**The Woodlands Off-Site Sanitary Lift Station, Force Main & Gravity Sewer Line A (RFCSP)**

**Solicitation Number: CO-00682**

**ADDENDUM 3**

**November 15, 2023**

JOB NUMBER:	SA190-0404.426
SHEET NO.	E-10

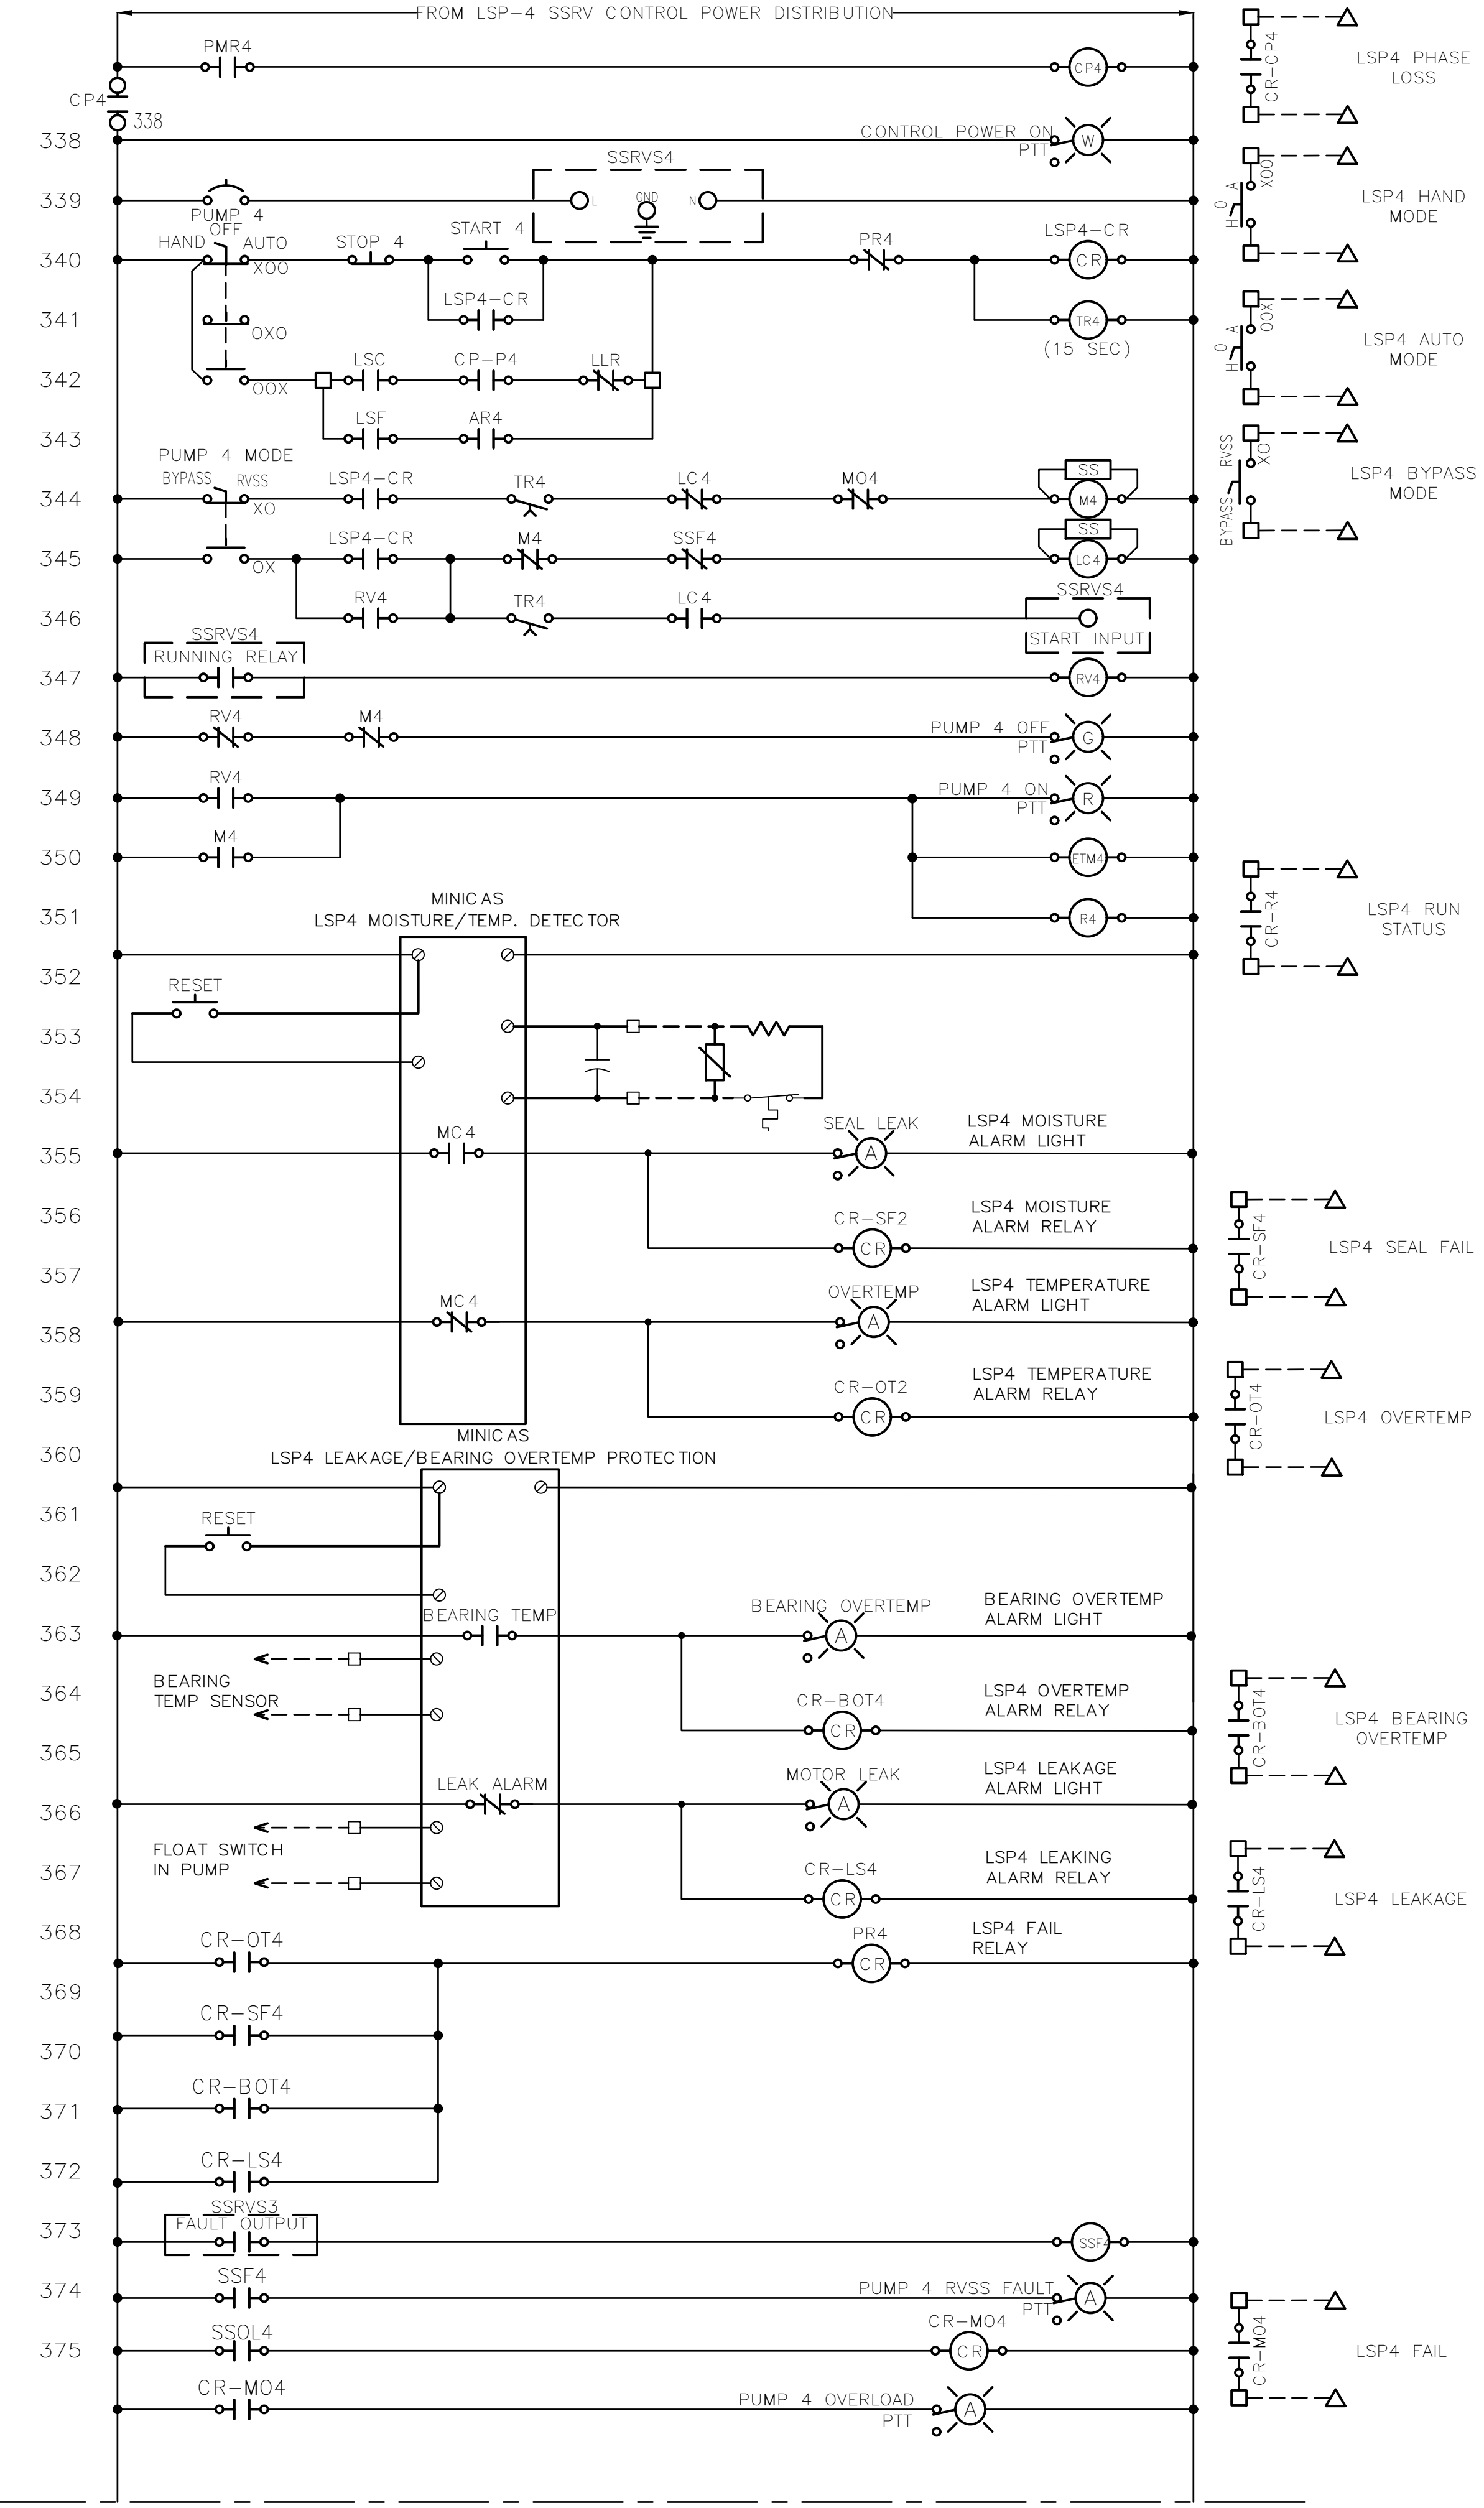
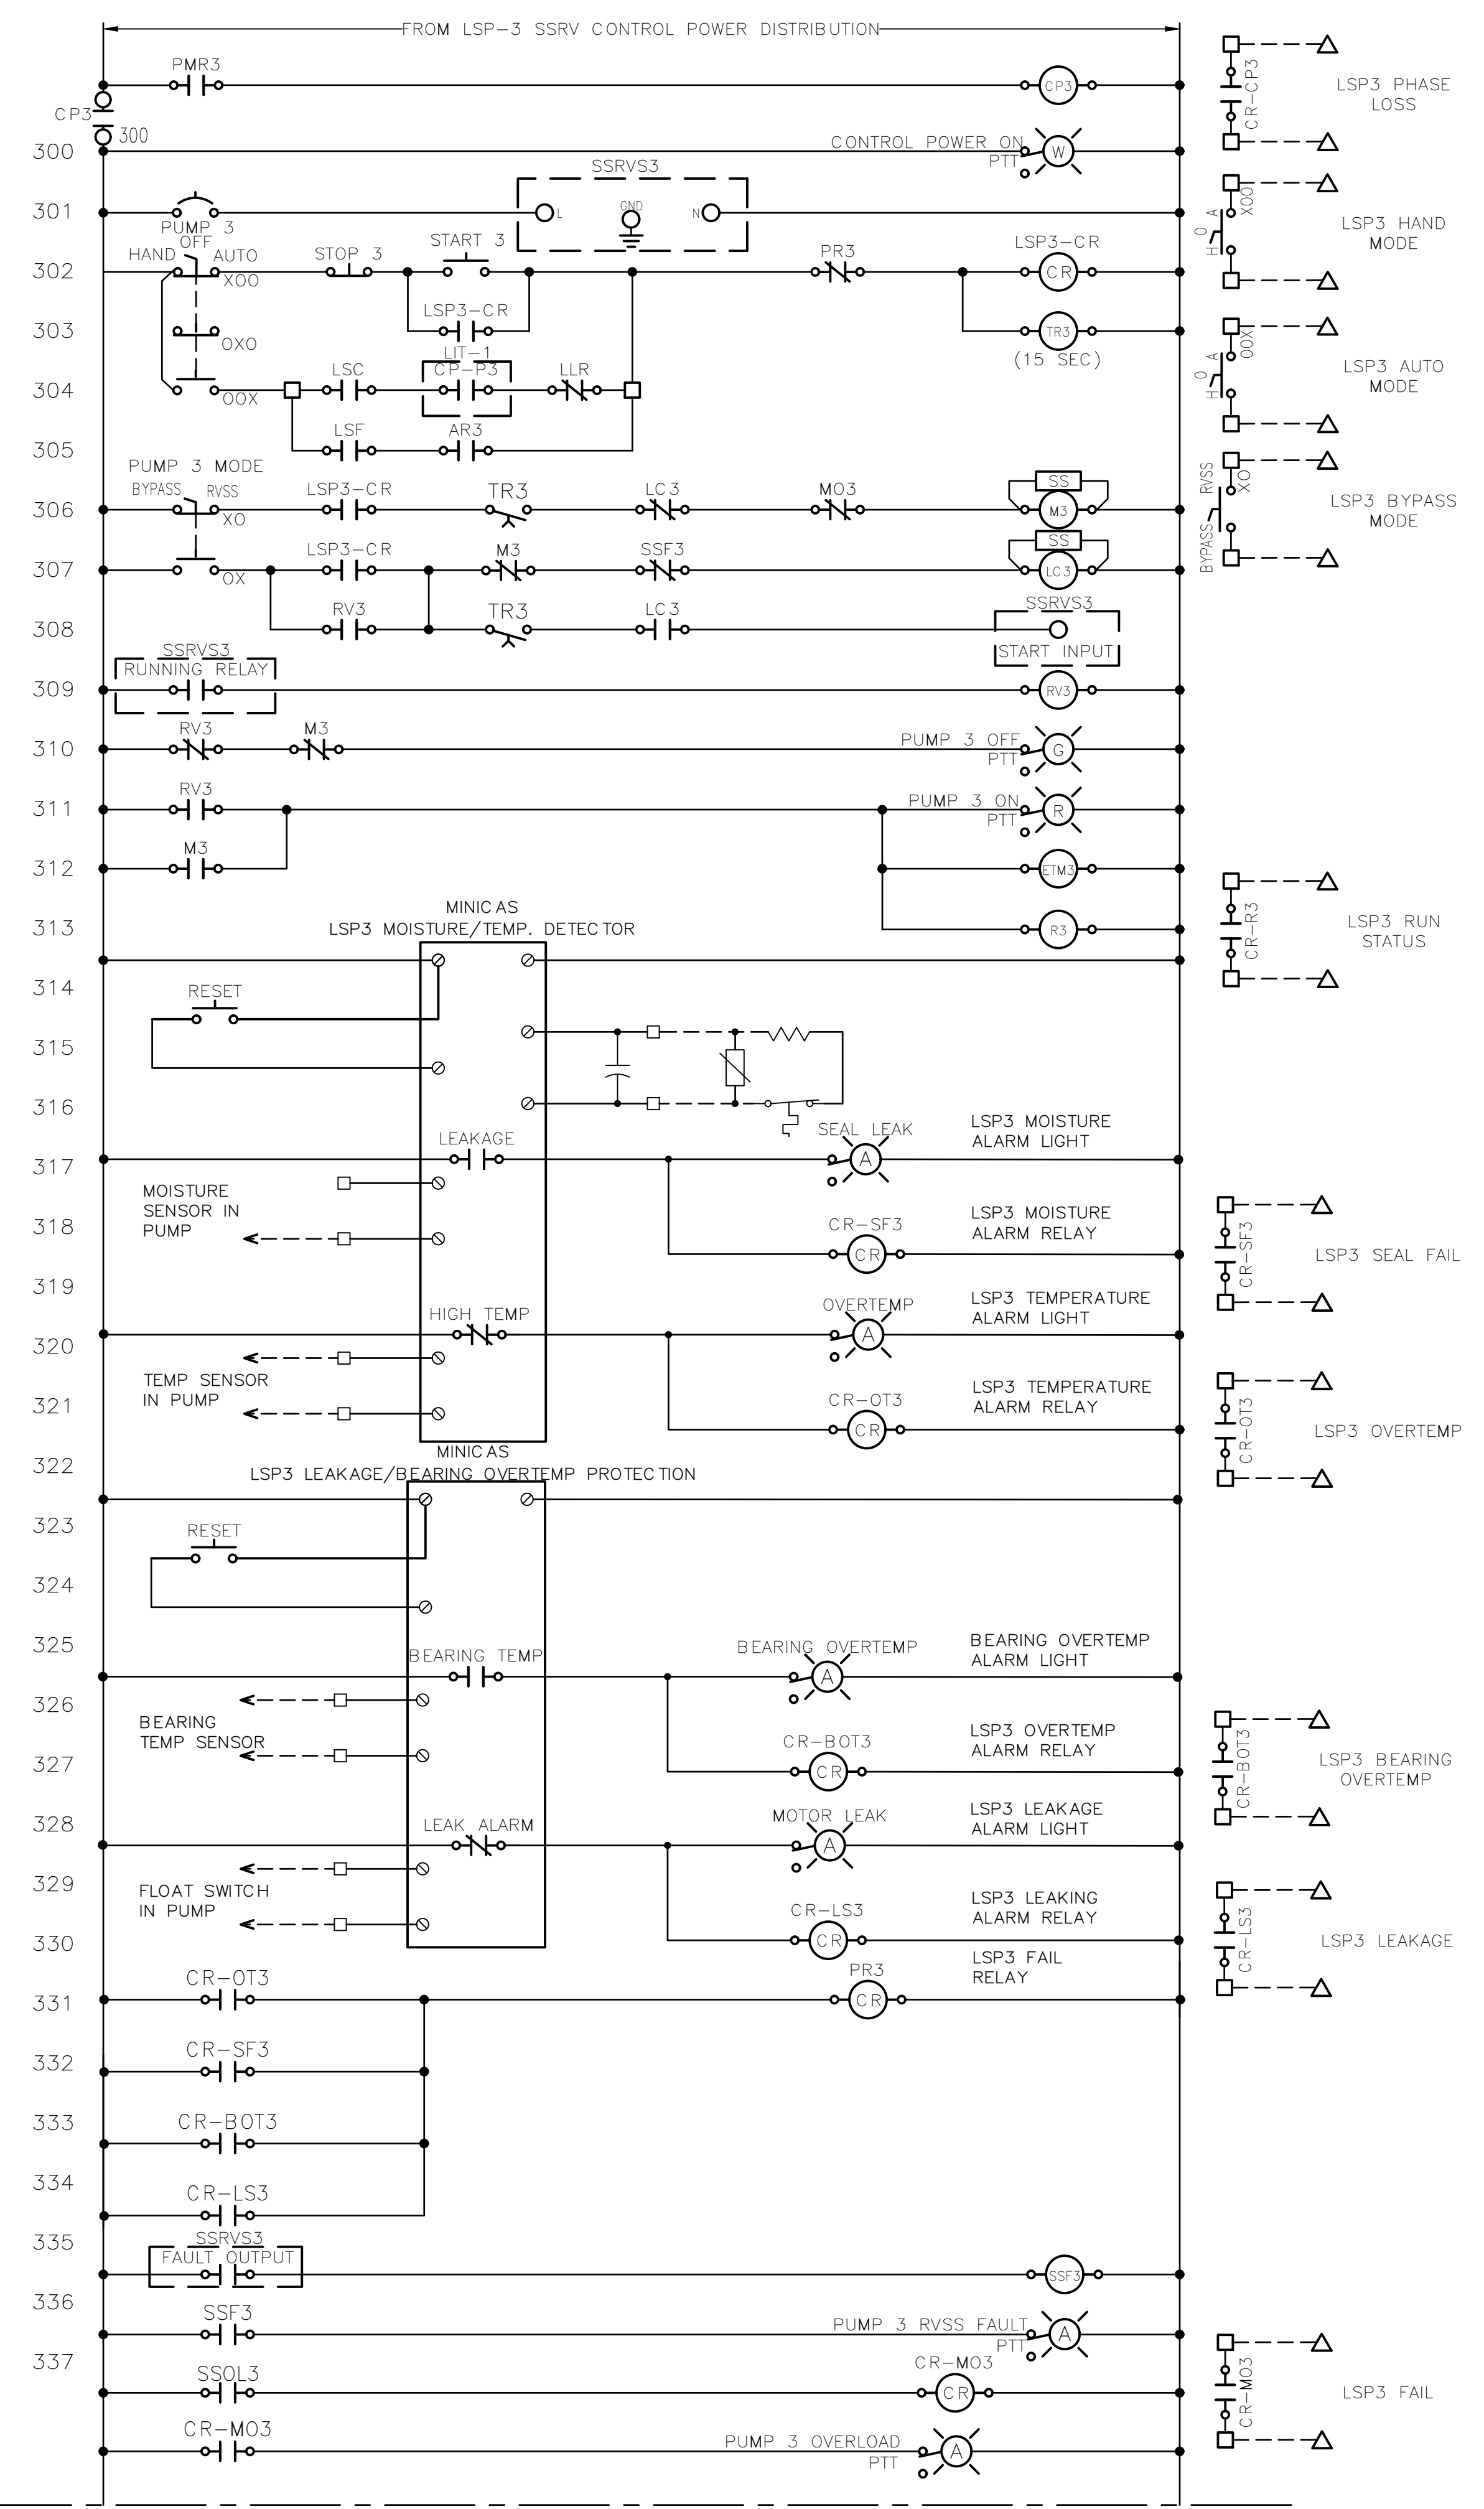
34. **Question:** There is a conflict in the drawings and the spec for the pump sensor relays. Flygt does not make a pump sensor relay to monitor the thermals, the leak and the bearing temperature. To accomplish this, a separate sensor cable has to be run. The specs call for the MAS 801 to be used which is a two wire system to monitor multiple pump sensors. This uses the set of control wires from the power cable to accomplish this.

**Answer:** *There will be two Minicas pump sensors installed per pump. See Changes to the Plans #1. Sheets E-10, E-11, and E-20 have been revised accordingly.*
